Access Compliance Report Public Rights-of-Way (Curb Ramps)

Main Street: PAPETTE_CIR		Cross Street: COUSTEAU_LN		Location:	NE
--------------------------	--	---------------------------	--	-----------	----

ADA ID: RPRK211110135933	Ramp Type: Type 4 - Parallel	Initial Pass/Fail: Fail	Overall Compliance: No	Severity Score:	2
--------------------------	------------------------------	-------------------------	------------------------	-----------------	---

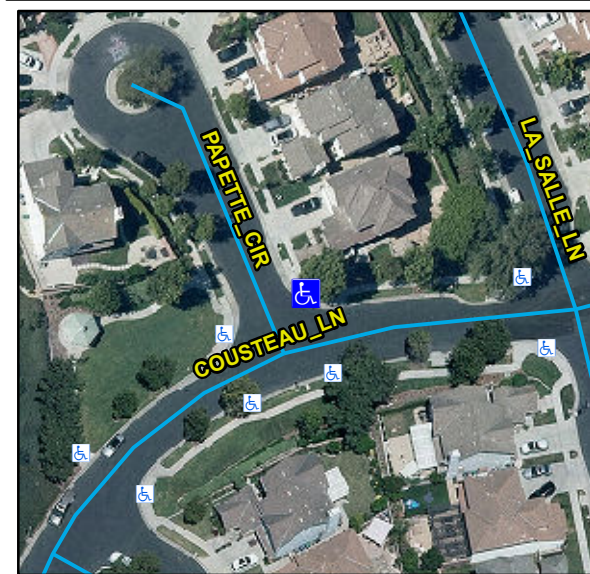
Compliance	Description	Data	Compliance	Description	Data
N/A	Ramp Length LT (in)	138	N/A	Ramp Length RT (in)	142
Yes	Ramp Width LT (in)	53	Yes	Ramp Width RT (in)	53
Yes	Ramp Run Slope LT (%)	4.2	Yes	Ramp Run Slope RT (%)	5.6
Yes	Ramp Cross Slope LT (%)	0.5	No	Ramp Cross Slope RT (%)	3.9
N/A	Landing Present	N/A	N/A	DWS Provided	N/A
N/A	Landing Length (in)	N/A	N/A	DWS Contrast	N/A
N/A	Landing Width (in)	N/A	N/A	DWS Length (in)	N/A
N/A	Landing Run Slope (%)	N/A	N/A	DWS Full Width	N/A
N/A	Landing Cross Slope (%)	N/A		DWS Offset Type	N/A
N/A	Landing Movement Obstructed?	N/A	N/A	DWS Offset Left (in)	N/A
	Landing Movement Type	N/A	N/A	DWS Offset Right (in)	N/A
N/A	Landing Shared	N/A			
N/A	Clear Space	Yes			
N/A	Clear Space To Crosswalk (in)	N/A			
N/A	Marked Crosswalk 1	No	N/A	Marked Crosswalk 2	No
	Crossing 1 Direction	W		Crossing 2 Direction	S
	Marked Crosswalk 1 Width (in)	N/A		Marked Crosswalk 2 Width (in)	N/A

Remove & Replace Curb Ramp With Two New Directional Ramps or Equivalent.

R204.3, R304.5.3, STD 1115
